## **CoPTTM Update Note – effective 23 December 2008**

# **New requirements and recommendations for Truck Mounted Attenuator (TMA) appearance, mobile Advance Warning Variable Message Sign (AWVMS) and Light Arrow Systems**

**Section B3  
Specification:**

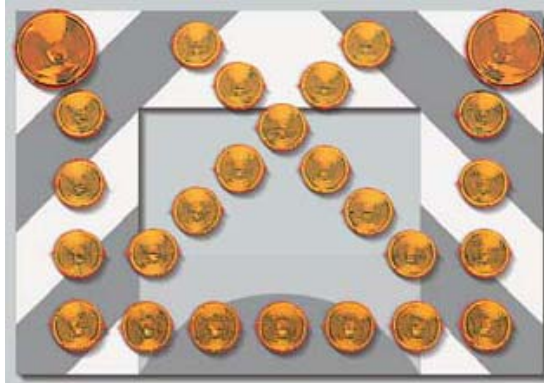
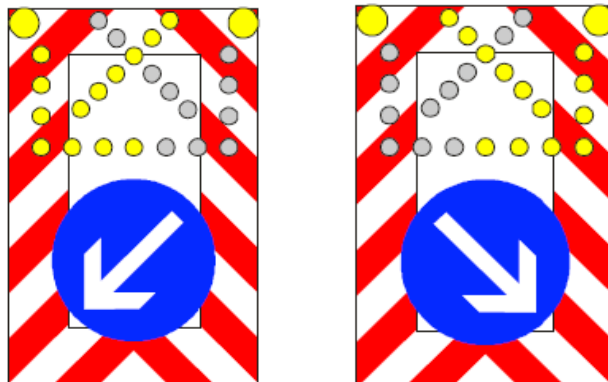
The details of the number and layout of lamps are shown in the diagram.

The minimum number of lamps shall be 24 with a maximum of 25.

The arrow lamps shall comply with *European Standard EN12352:2006 Traffic control equipment - Warning and safety light devices* for Class L8H warning lights.

The arrow lamps are required to pulse at a rate of 55 to 75 flashes per minute, with the on-period twice the length of the off-period. When the arrow lamps are operating the two synchronised xenon flashing lights shall only flash during the off-period of the arrow lamps.

The lens must be amber or yellow in colour.

Adjustment of the light intensity of the lanterns for night-time operations shall be controlled by an automatic light-sensitive multistage light dimming device.

The light intensity during hours of darkness should not exceed a maximum value of 800 candelas since this may cause glare and make the sign difficult to read.

## Section B4 Operational Principles

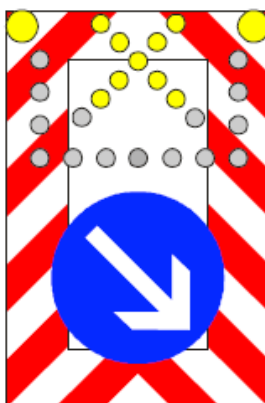
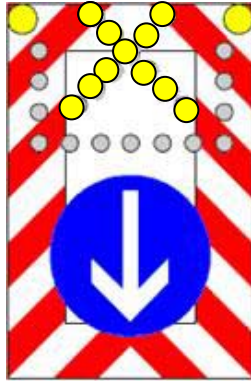
- **Arrow** ~ Lane change required (because a driving lane is closed)

- **Cross** ~ A part of the roadway which is not used for driving is closed (usually a shoulder) – it is safe to pass on the side indicated by the RG17 / 34 sign

- **Proposal only - Xenon Lamps and cross with arrow down** A part of the roadway which is used for driving is closed road users to follow the TMA without overtaking – no overtaking.
- **Note** the white RG arrow must go either left or right while the TMA is stationary, the vertical down or up position is not an official sign.
- **Note** ~ RG17 / 34 sign must not be visible when TMA is not engaged in traffic management.

A comprehension survey has been undertaken and this system failed to reach an acceptable level of understanding amongst motorists. The downward pointing arrow is currently not a gazetted sign and should not be used at present.

As an interim measure, where a part of the roadway which is used for driving is closed and road users are to follow the TMA without overtaking, place the light arrow on cross and cover the RG 17/34 arrow below.

**Figure C1 TMA for Level 2/3 roads**

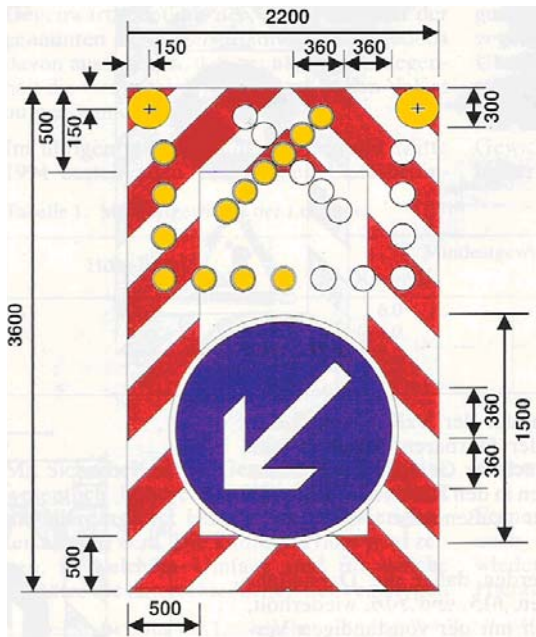
**Height:** The overall height of the panel shall not exceed 4.25m above the road. The lower 500mm panel may need to be installed on the rear of the TMA to remain under the maximum height specified in law.

**Enlarged RG17:** 1500mm diameter (+or - 50mm). The sign shall be illuminated by the installation of white lighting with a minimum output of 50 watt.

**Xenon Lights:** Are to be installed in the top left and right hand corner of the panel as per the drawing.

**Equipment Control:** The rear panel shall have a device installed to ensure that the arrowboard and the RG17 are always aligned. A display must be visible to the operator to confirm orientation.

**Deck Mounted Uplighting:** An upright is to be attached to the deck to adequately illuminate the RG 17/34.

**Organisations' signage or logos:** must not be installed on the rear panel.

Maximum height to top of display from ground level must not exceed 4.25m

**Section C4  
Level 1 Roads**

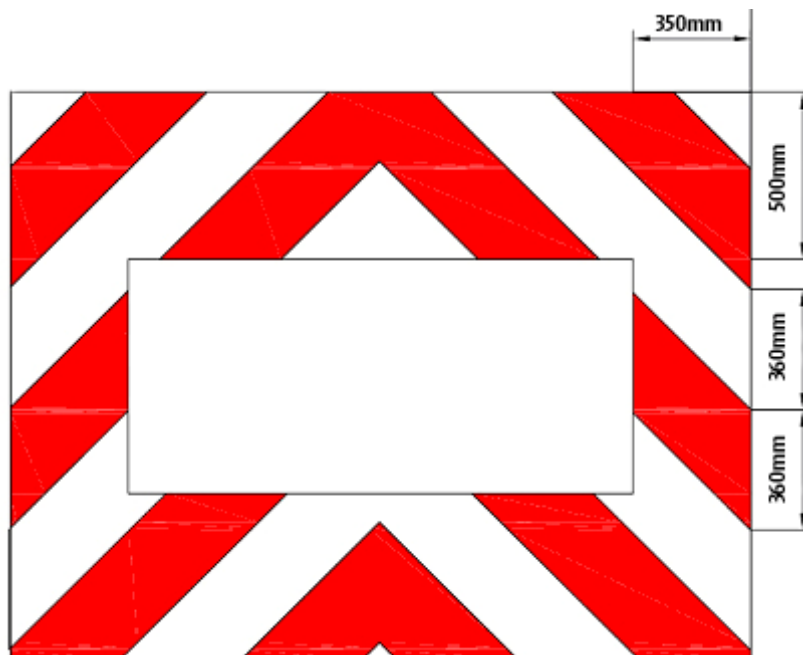
NZTA's long term vision is to create consistency within the New Zealand Network and would encourage the retrofitting of existing rear panels to match the same red/white pattern as used in the new panel display.
